SUNDRY NOTICES AND REPORTS ON WELLS (DO NOT USE THIS FORM FOR PROPOSALS TO DRILL OR TO DEEPEN OR PLUG BACK TO A DIFFERENT RESERVOIR. USE "APPLICATION FOR PERMIT" (FORM C-101) FOR SUCH PROPOSALS.)		WELL API NO. 30-015-27008 30-015-27008

2. Name of Operator CHEVRON USA INC		6. State Oil & Gas Lease No.
3. Address of Operator 15 SMITH RD MIDLAND TX 79705		7. Lease Name or Unit Agreement Name USA CACTUS 16 STATE

CONDITIONS OF APPROVAL FOR PLUGGING & ABANDONMENT

Well Name & Number: USA Cactus 16 State #1

Cactus 16 State No. 1
PROPOSED

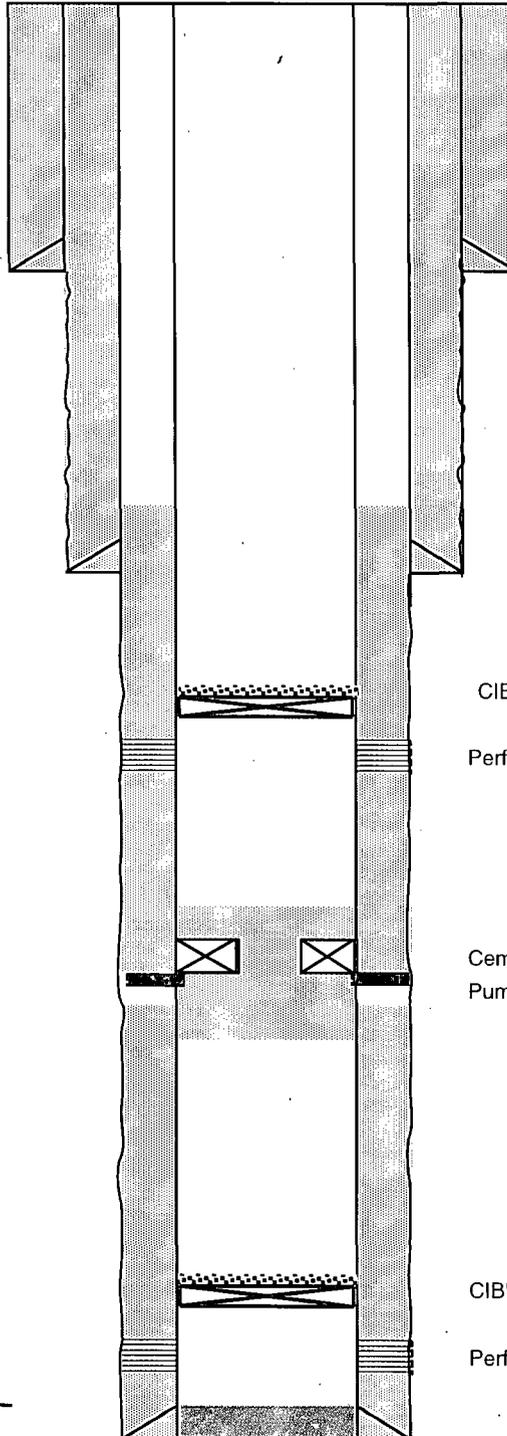
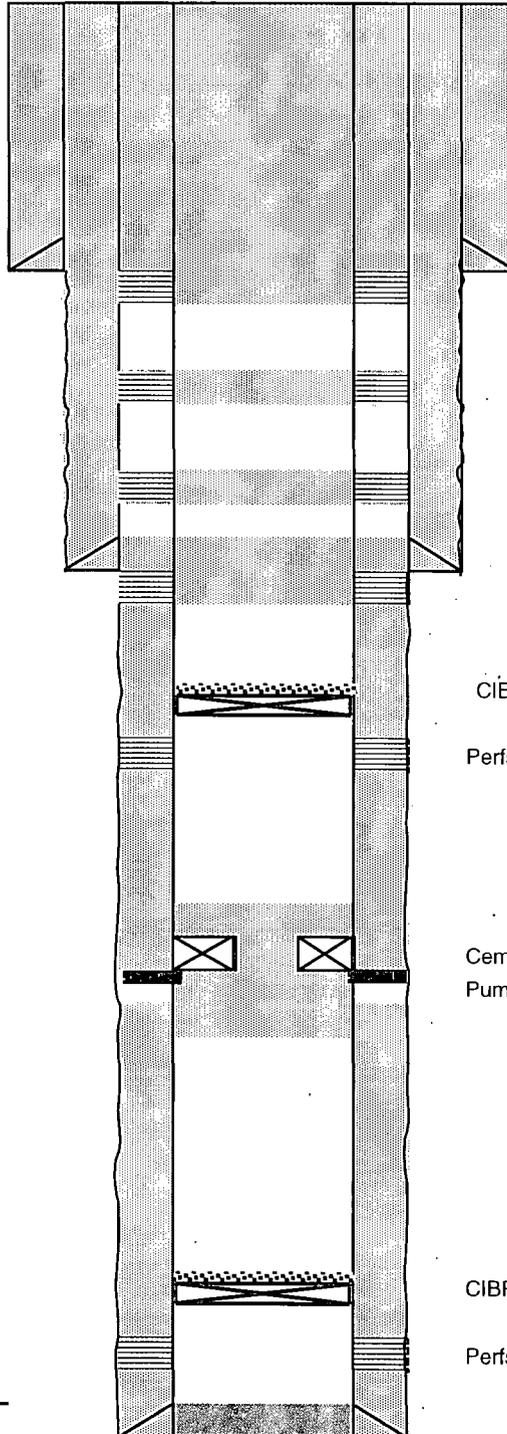
- CALL NMOCD 24 HRS. PRIOR TO MOVING IN RIG.
- TAG TOC @ 5915'. SPOT 255X5 CMT @ 5915'
- PERF & SQZ 5-1/2" CSG W/60 SXS OF CLASS "C" CMT FROM 4300 - 4100'. WOC&TAG. (SHOE)
- PERF & SQZ 5-1/2" CSG W/60 SXS OF CLASS "C" CMT FROM 3855' - 3655'. WOC&TAG. (B.SALT)
- PERF & SQZ 5-1/2" CSG W/60 SXS OF CLASS "C" CMT FROM 2810 - 2610'. WOC&TAG. (T.SALT)
- PERF CSG @ 520' AND ATTEMPT TO CIRC. A 520' CMT PLUG I/O 5-1/2" CSG. W/160 SXS OF CLASS "C" CMT ALL CSG & ANCHORS TO BE CUT & REMOVED 3' BELOW GRADE, CLOSED LOOP SYSTEM WILL BE UTILIZED.

7. Every attempt must be made to clean the well bore out to below the perms, before any plugs can be set, by whatever means possible.
8. **Cement Retainers may not be used.**

9. **Squeeze pressures are not to exceed 500 PSI, unless approval is given by NMOCD.**
10. **Plugs may be combined after consulting with and getting approval from NMOCD.**

11. **Minimum WOC time for tag plugs will be 4 Hrs.**
